Ref. No.: MCHI/PRES/18-19/263

**Subject:-** Issue concerning building height permissions issued by AAI - Obstacle Limitation Surface

## **APPENDIX 1 - TECHNICAL NOTE ON OLS CALCULATIONS**

Figure 1.3.

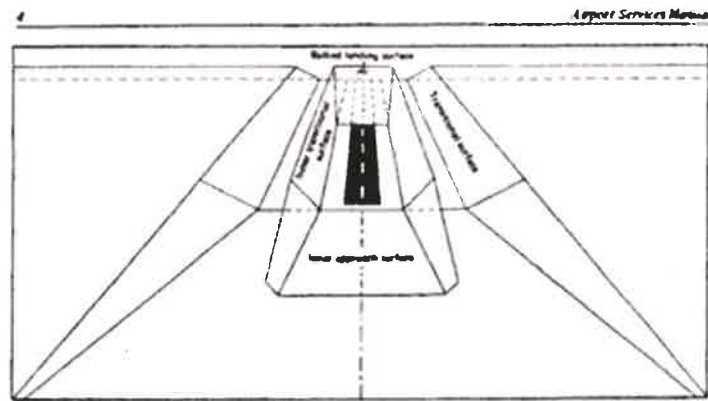
1. The objective of Transitional Surface and the Inner Horizontal Surface ( I H S) are different.
2. Transitional surface is a complex surface **along the side of the runway strip and part of the side of the approach surface**, that slopes upwards and outwards to the inner horizontal surface.

- a) **Area 1 : Along the length of the strip parallel to the runway centre line;** The corresponding Runway Strip is considered as Reference Point for transitional surface limitations calculation. i.e., datum is Runway Centerline. The Same concept is applicable for I H S central portion (Along the length of the strip parallel to the runway centre line). No deviation from design concept of Transitional Surface and I HS reference point for calculation and hence uniform and gradual is maintained from the runway centerline.

- b) **Area 2: Part of the side of the Approach Surface :** A lower edge beginning at the intersection of the side of the approach surface with the inner horizontal surface and extending down the side of the approach surface to the inner edge of the inner edge of the approach surface . The inner edge of the approach surface ( Distance from runway threshold / runway end when threshold is located on extremity of runway) is considered as Reference Point for transitional surface limitations calculation. i.e., **datum is Runway End** , Two part calculations i.e. First – Distance (Longitudinal) from the approach surface inner edge to centerline intersection point from object + Second – distance (Lateral) from the edge of approach surface and object. Reference Point is Runway Extremity. Hence, **Longitudinal and Lateral distances** are considered for Transitional surface calculations. **(Not only Lateral distance in the side of approach surface area).** No deviation from design concept in the Transitional Surface calculations. Hence , Calculation of the height in the transitional surface is also done similarly (only shortest distance ignoring OLS reference point) is contrary to the transitional surface limitations specifications (visible deviation) and not valid.

The Similar concept is applicable for I H S side of the approach surface ( **Other than Central portion - Along the length of the strip parallel to the runway centre line**). The calculation being made by AAI completely ignores the reference point i.e. the centre line

Figure 1-1. Inner horizontal surface for a single runway (where the runway code number is 4)

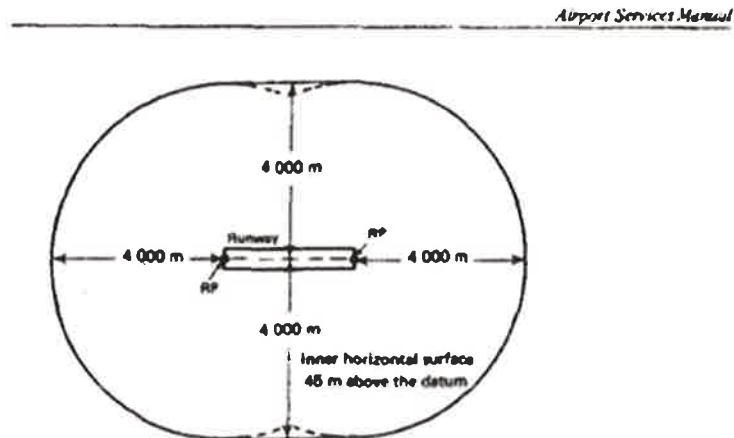
The IHS is itself measured as a radius from the end of the centre line of the runway. Therefore, the distance of the buildings from the runway end is the relevant criteria to be taken into account. At the same time, the distance of the building from the end of transitional surface has also to be taken into account to comply with the Guidelines Recommendations. Both the aforesaid points [namely End of Runway and End of Transitional Surface] are relevant and one cannot be ignored. In this view of the matter, the real estate industry has repeatedly represented to the Airport Authority of India, Civil Aviation Ministry, etc that the distance of the buildings should be calculated from the "intersection" of the point where a line drawn from the reference point, i.e. from the end of the runway, intersects the end of transitional surface.

This would ensure that the reference point i.e. the distance from the runway is factored in and the height of the building is determined with reference to the runway, but at the same time distance is calculated from the end of transitional surface [as per the Guidelines Recommendation].

No deviation from design concept of Transitional Surface and IHS reference point for calculation and hence uniform and gradual is maintained from the runway centerline/end.

The interpretation being given by AAI that the height of the building would depend upon the shortest distance of the building from the end of the transitional surface, without reference to the distance of building from the runway, is contrary to the OLS design Specifications Standards as regard to the reference point of measurement and objective of Guidelines, for restriction/ penetration above OLS by objects, even though

Thus, the distance from the runway end (Reference Point) shall be considered to meet the objective of the additional restriction criteria has to be taken into account.
